Re: **25/01859/OUTFUL** "Warneford Park" planning application - Oxfordshire Liveable Streets comments

This is Part 3 of our response to this development application, responding to the revised transport plans posted on 9th January.

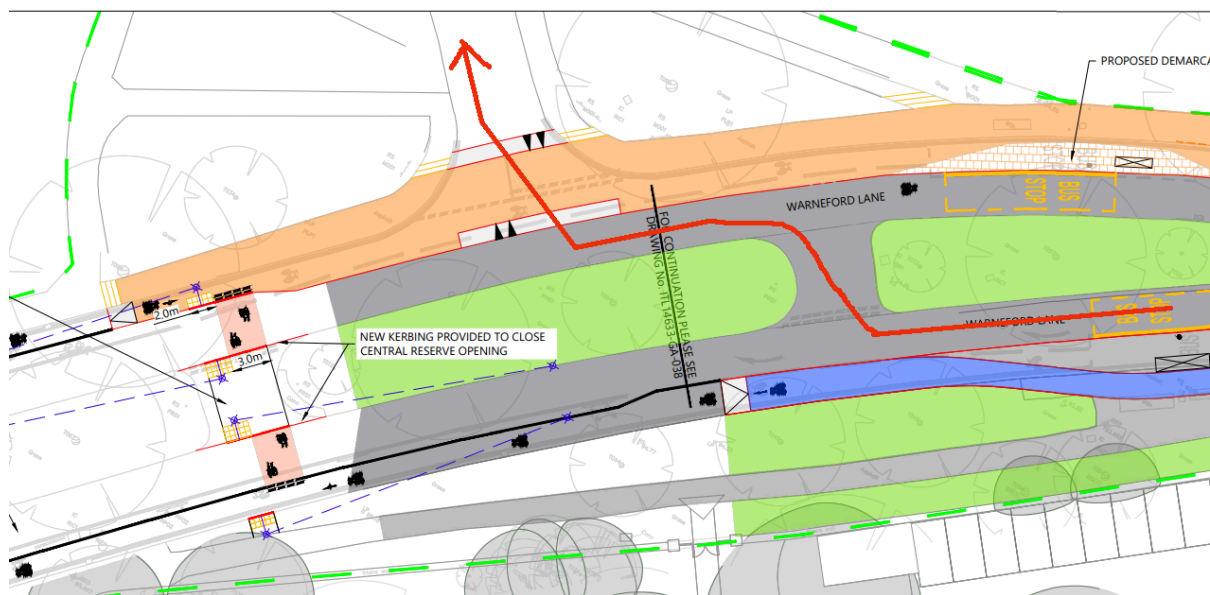
Our one major concern now is with the design of Warneford Lane, and in particular with the proposed closure of the western u-turn allowing access to Cheney Lane. This will push more motor traffic onto the roundabout at the Divinity Rd-Morrell Ave-Warneford Lane roundabout, which already carries significantly too much traffic for cycling to be accessible (well over the 2000pcu/day threshold in LTN 1/20). It will also result, when traffic levels are low, in some drivers using the eastern u-turn illegally, performing the manoeuvre illustrated below, which will save them 0.5 kilometres or about a minute.

This will create a significant hazard, especially for people walking and cycling who will not be expecting or looking out for vehicles approaching from the wrong direction.
